REQUEST FOR INFORMATION
BID PACK B

PROJECT: SILVER LAKE ELEMENTARY SCHOOL

ENERGY RECOVERY UNIT DETAIL

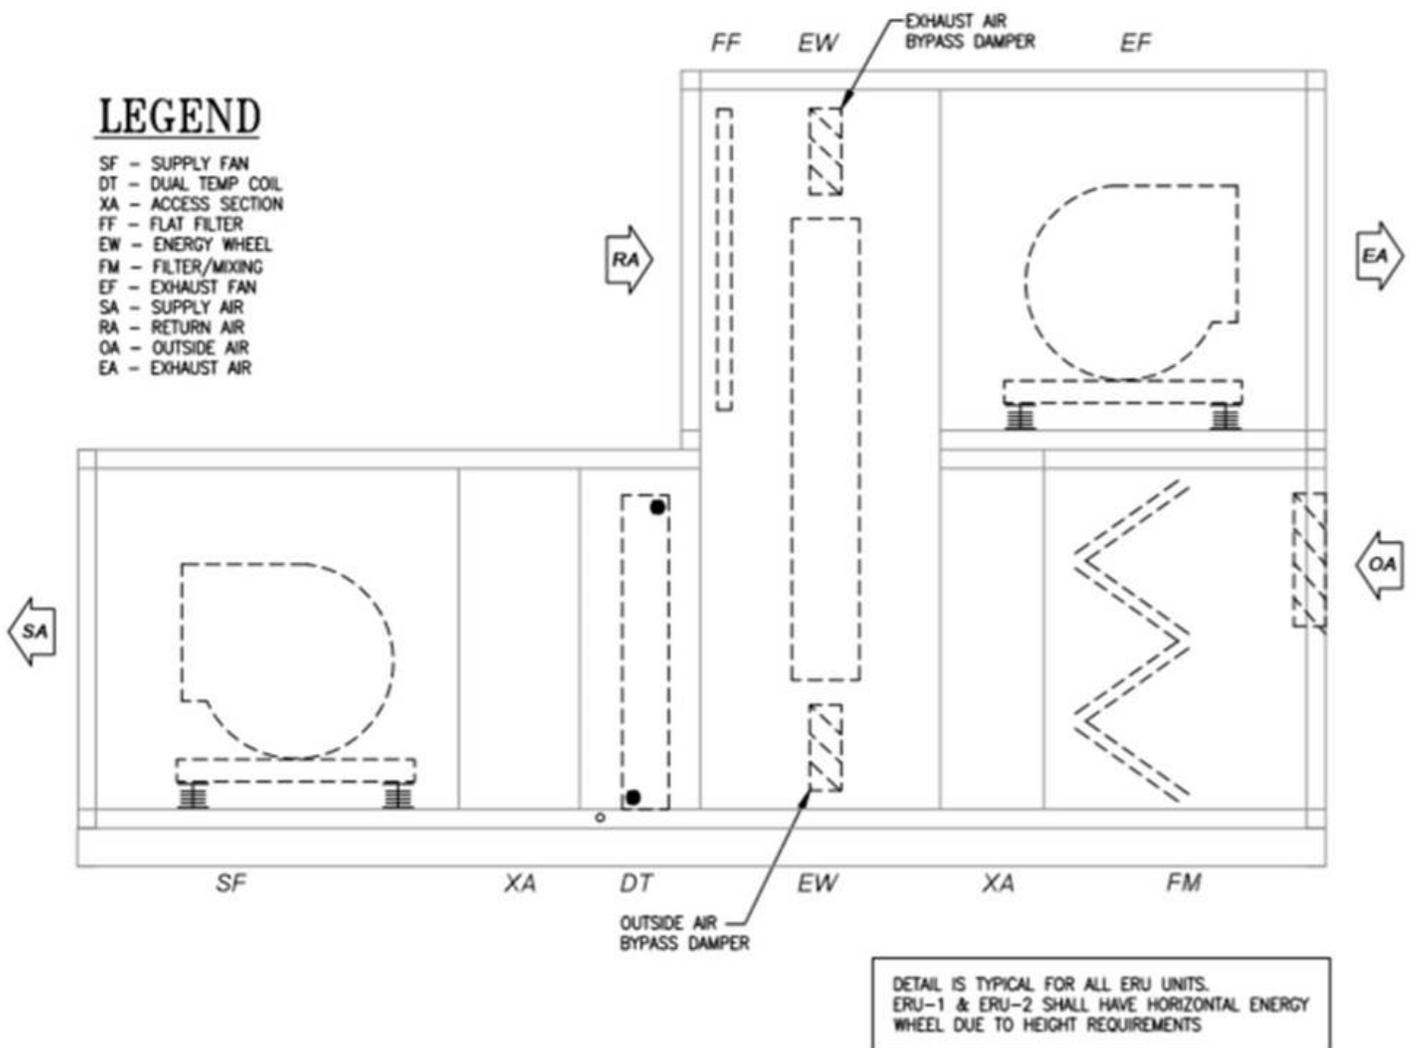
- 1.) What is the maximum unit height acceptable for ERU-1,2?
- 2.) Do ERU-1,2 have an energy recovery wheel mounted perpendicular to the floor with two airstreams in a side by side air tunnel arrangement?

1. What is the maximum unit height acceptable for ERU-1,2?

2. Do ERU-1,2 have an energy recovery wheel mounted perpendicular to the floor with two airstreams in a side by side air tunnel arrangement?

- 1.) Clearance between the mezzanines and structural steel vary between 4'-7" and 6'-0". Refer to architectural and structural drawings for exact clearance & location of steel.
- 2.) The energy wheel in ERU-1 & 2 is mounted horizontal, parallel to the floor.
